## FINAL PRODUCT/PROCESS CHANGE NOTIFICATION #16504

Issue Date: 30-Jul-2010

**TITLE:** Qualification of Serial SPI EEPROM devices CAT25080, CAT25160 and CAT25640 for fabrication at ON Semiconductor's Gresham, Oregon Wafer Fab

##### 1) SOIC -150mil 8pin (W, V), SOIC – 208mil 8pin (X)

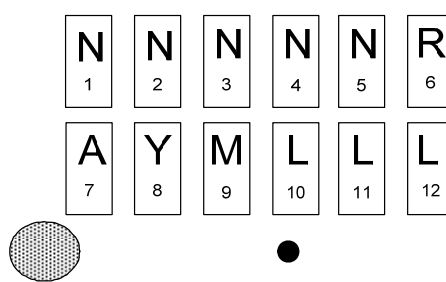
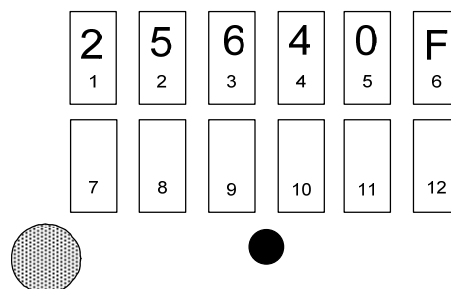
###### Current OKI die

###### FRONT SIDE MARK:

- 1: Assembly location code
- 2: Mark "4" for (lead finish NiPdAu)
- 3: Product Revision
- 4-9: Product Name: "PPPPPP"
- 10: Temp Range (I=Industrial; E=Extended)
- 11: Production Year (last digit)
- 12: Production Month (1-9, A,B,C)
- 13-16: Last four digits of assembly lot number

###### New Gresham die

###### FRONT SIDE MARK:

- 1-5: Device name(5 char)
- 6: Production Revision
- 7: Assembly location
- 8: Production Year
- 9: Production Month
- 10-12: Assembly Lot Number

### 2) TSSOP- 8pin (Y)

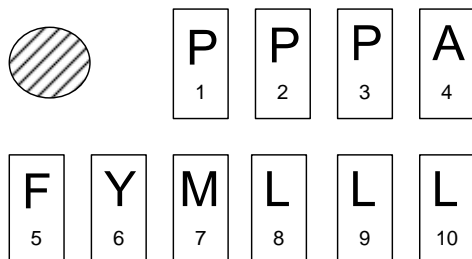
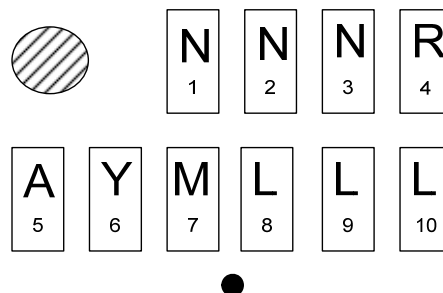
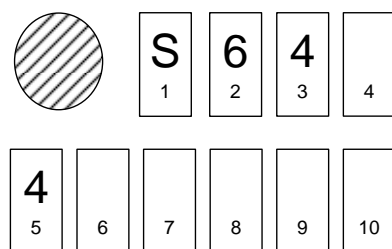
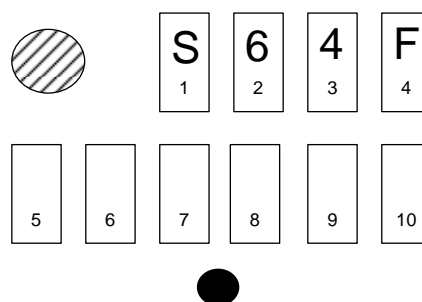
#### Current OKI die

#### New Gresham die

### FRONT SIDE MARK:

- 1-3: Device name "PPP"
- 4: Assembly location
- 5: Lead finish
- 6: Production Year
- 7: Production Month
- 8-10: Assembly Lot Number

### FRONT SIDE MARK:

- 1-3: Device name (3 digit)
- 4: Product Revision
- 5: Assembly location
- 6: Production Year
- 7: Production Month
- 8-10: Lot Number

### 3) TDFN 2x3mm (VP2) and UDFN 2x3mm (HU3, HU4)

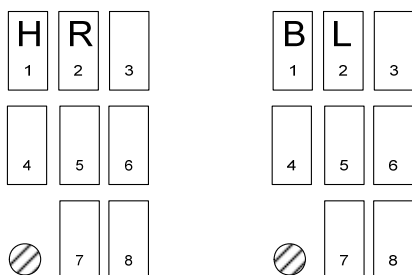
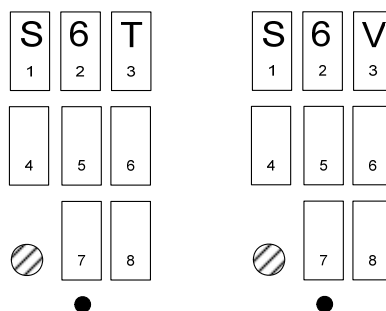
#### Current OKI die

#### FRONT SIDE MARK:

- 1-2: Device name
- 3: Assembly location
- 4-6: Lot Number
- 7: Production Year
- 8: Production Month

#### New Gresham die

#### FRONT SIDE MARK:

- 1-2: Device code
- 3: Code for revision and package
- 4: Assembly location
- 5-6: Lot Number
- 7: Production Year
- 8: Production Month

### 4) PDIP 8LD (L)

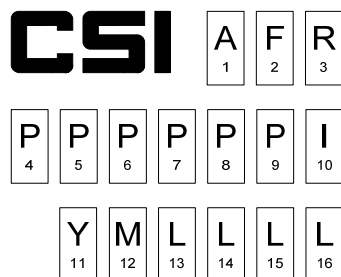
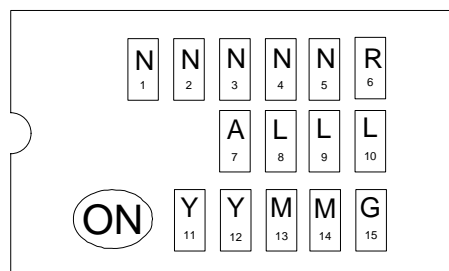
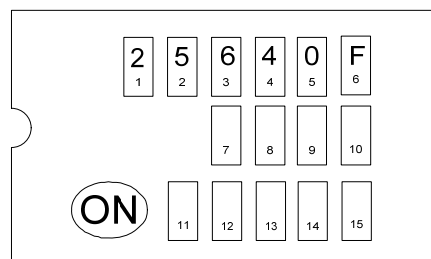
Current OKI die

#### FRONT SIDE MARK:

- 1: Assembly location code
- 2: Mark "4" for (lead finish NiPdAu)
- 3: Product Revision
- 4-9: Product Name: "PPPPPP"
- 10: Temp Range (I=Industrial; E=Extended)
- 11: Production Year (last digit)
- 12: Production Month (1-9, A,B,C)
- 13-16: Last four digits of assembly lot number

New Gresham die

1-5: Device name

6: Product Revision

7: Assembly location code

8-10: Assembly lot number

11-12: Production Year

13-14: Production Week

15: Pb-free designator
